Info Only: Engineering comments
are in blue text.

FINAL DRAINAGE REPORT
for
OWL MARKETPLACE FILNG NO. 1
PRE-SUBDIVISION GRADING

El Paso County File No. VR2321

Please update to
CDR247

LEGEND
 PIPE ID: 6
 DESIGN PT: DP1

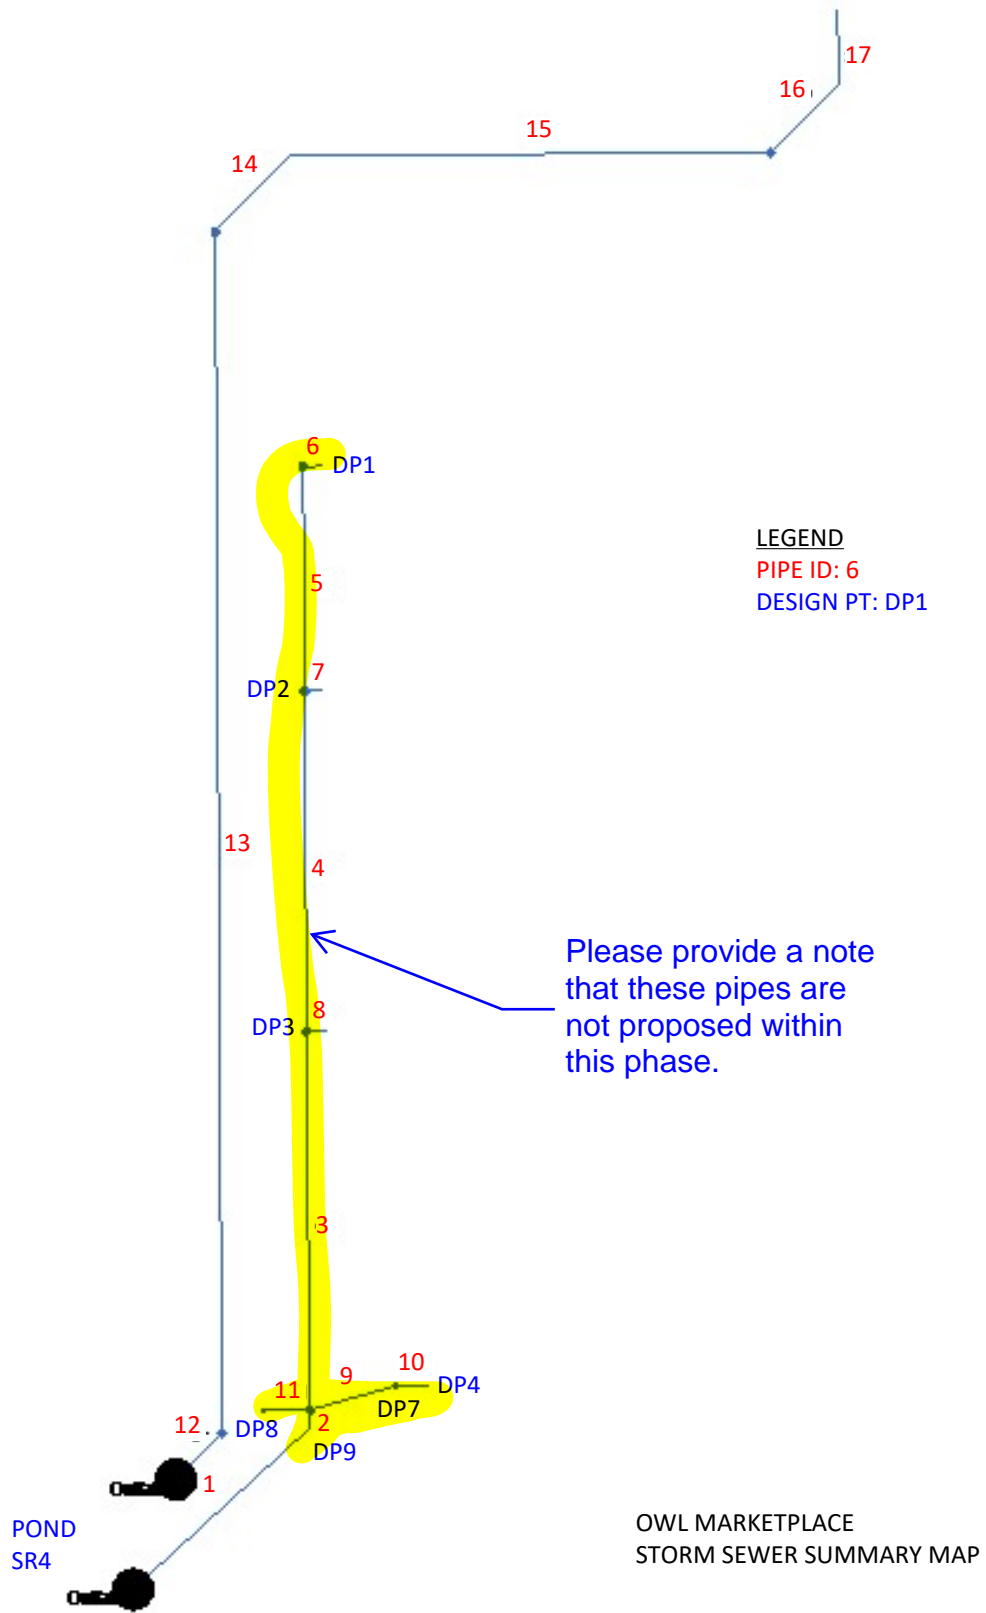
Please provide a note that these pipes are not proposed within this phase.

Project File: OP 5-YR REV3.stm

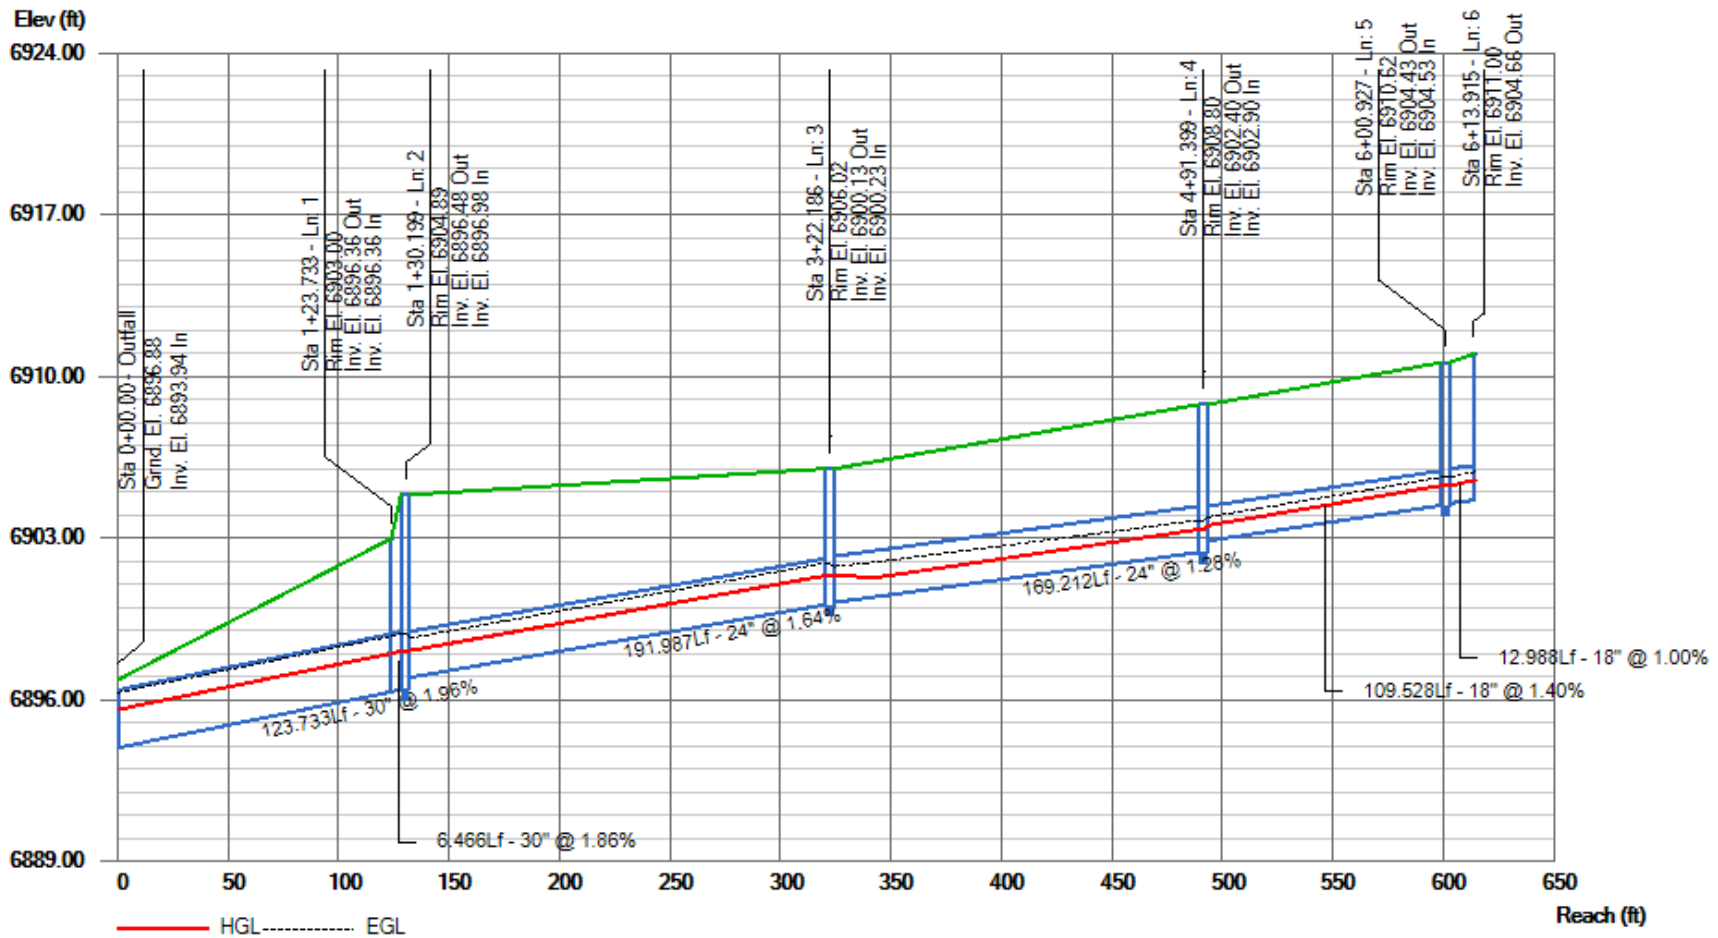
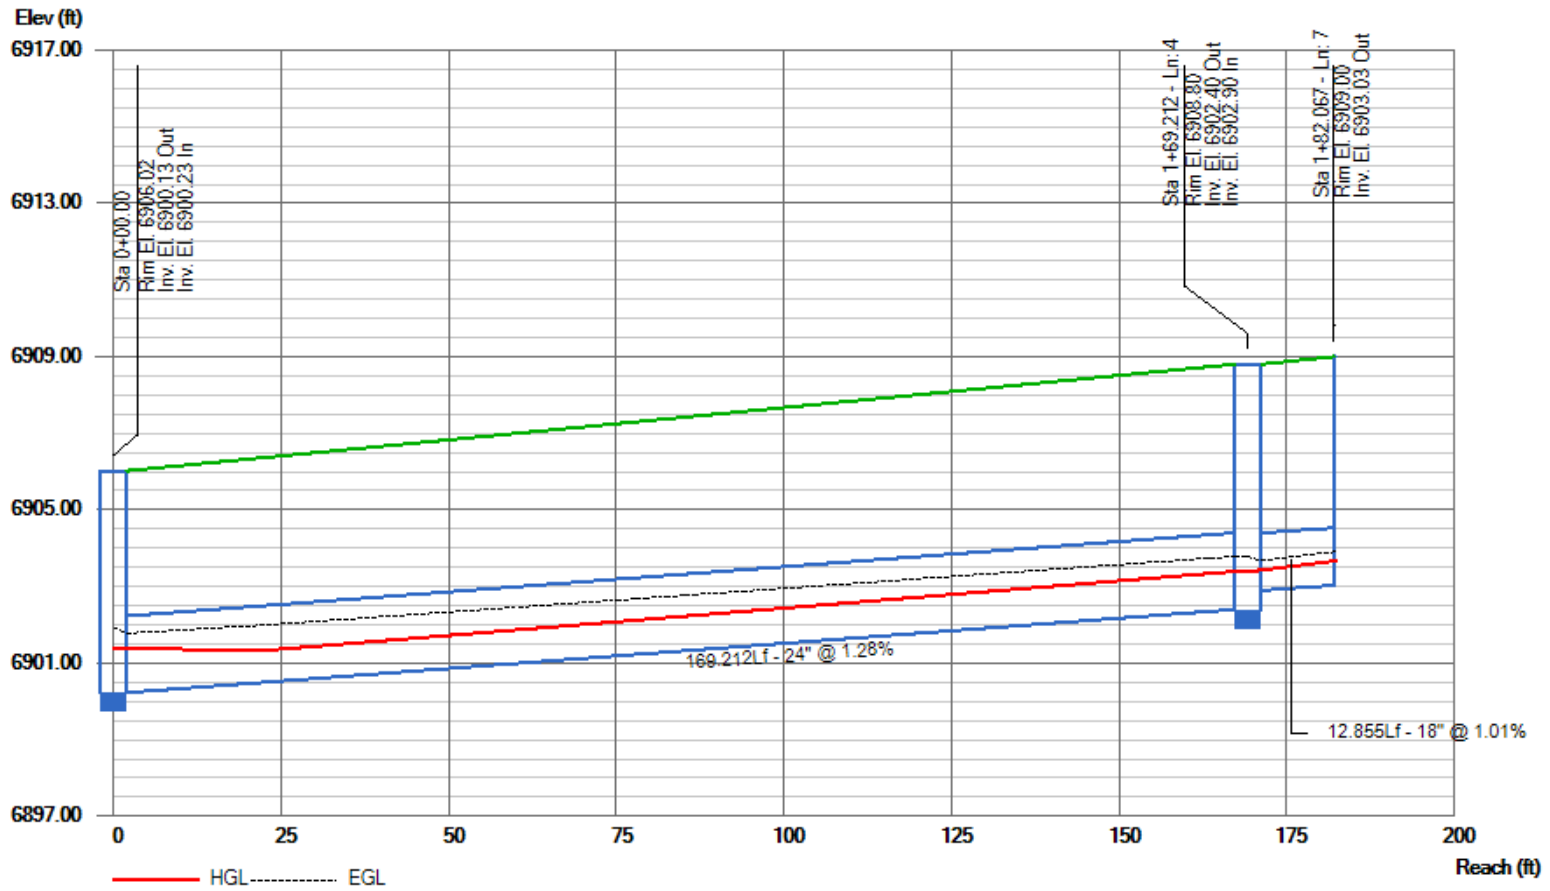
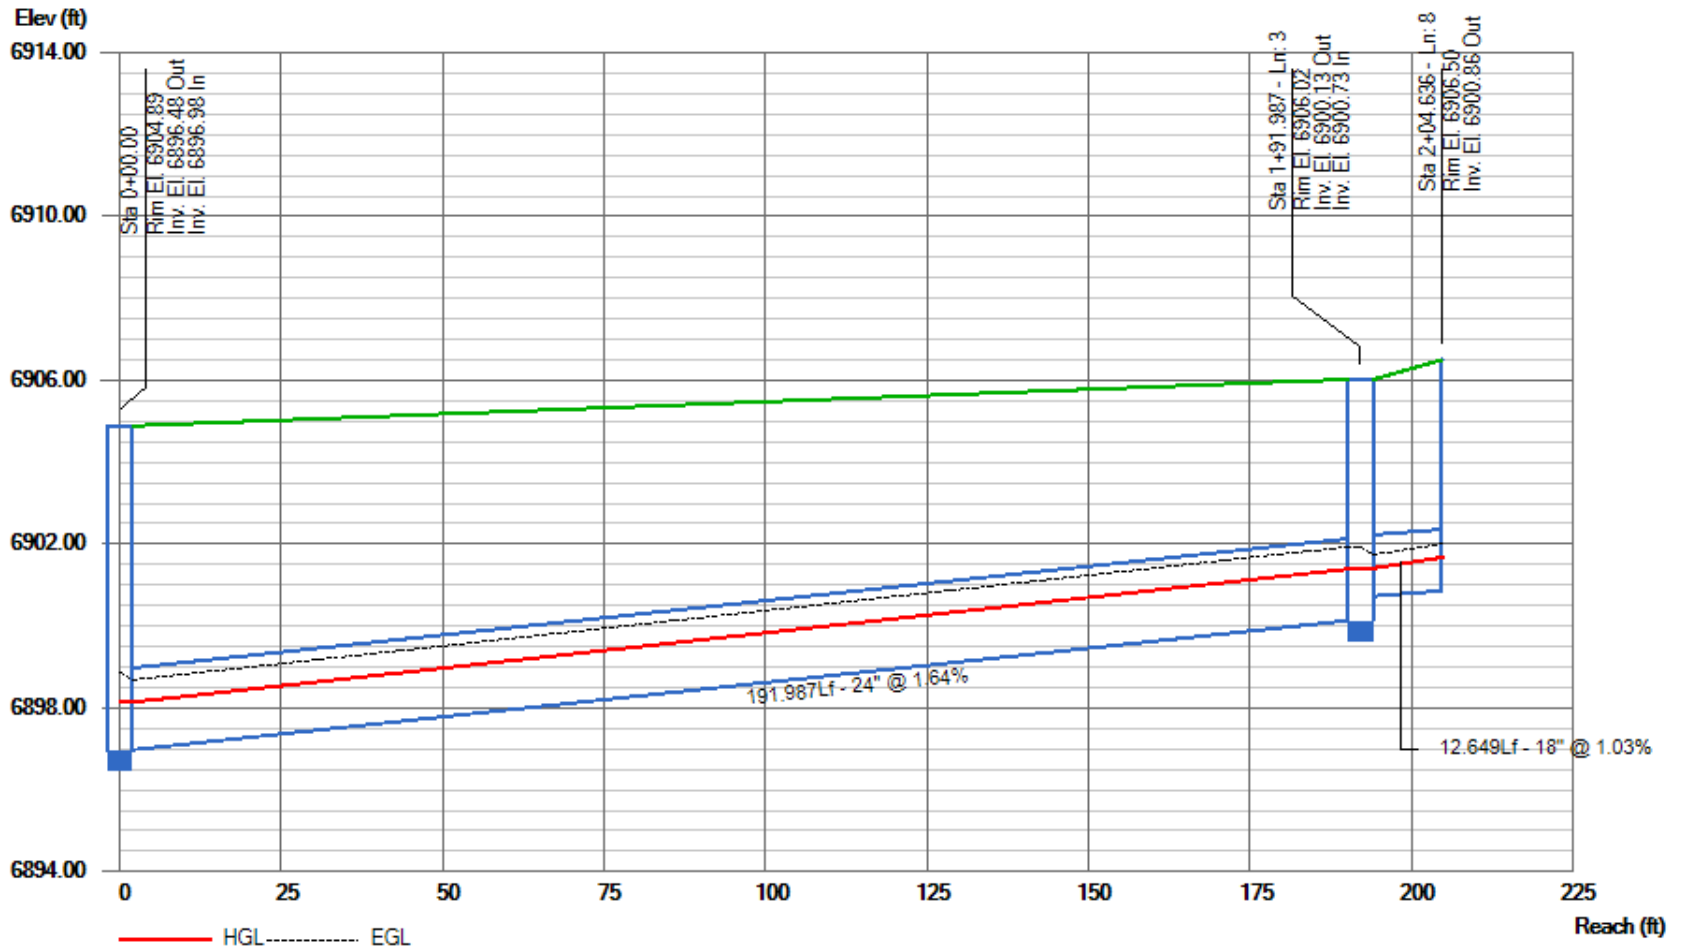
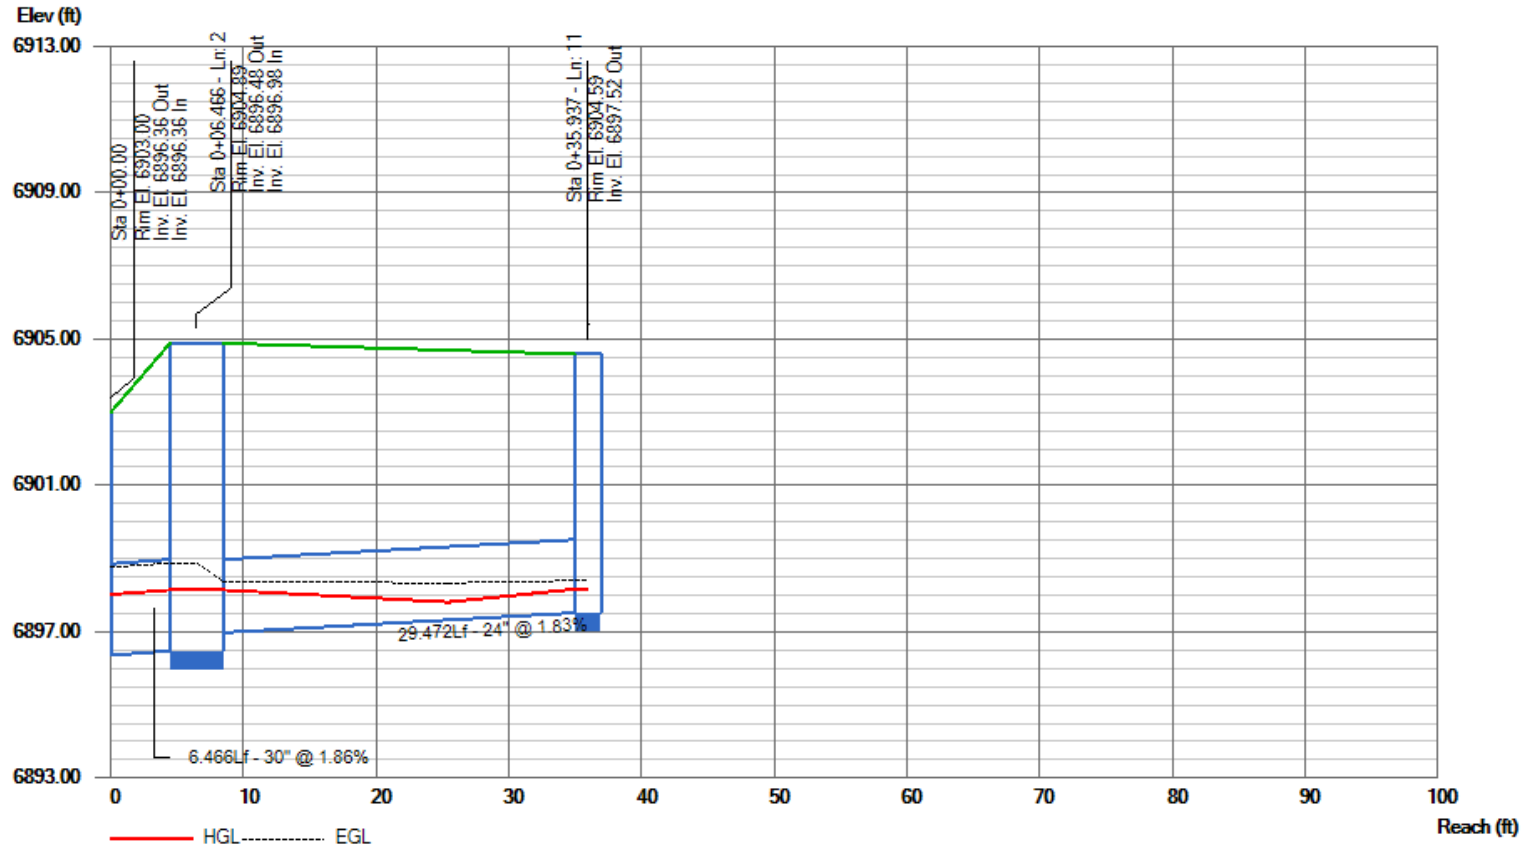
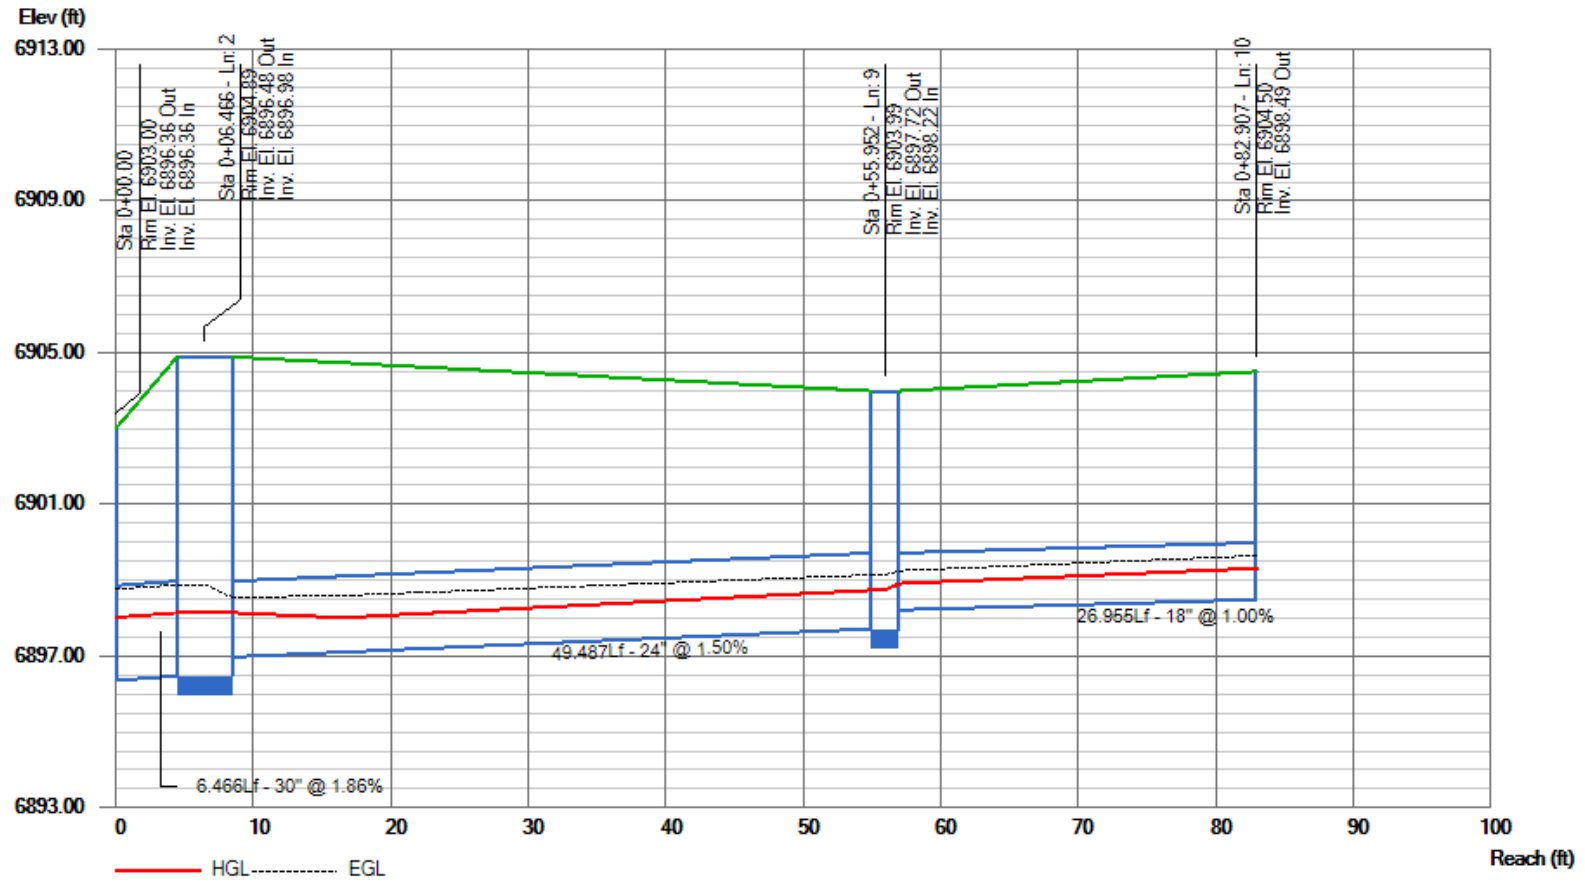
The velocity shall not fall below the minimum requirement of 4 ft/s or a minimum slope of 0.5%. Please adjust the VR2321 accordingly.
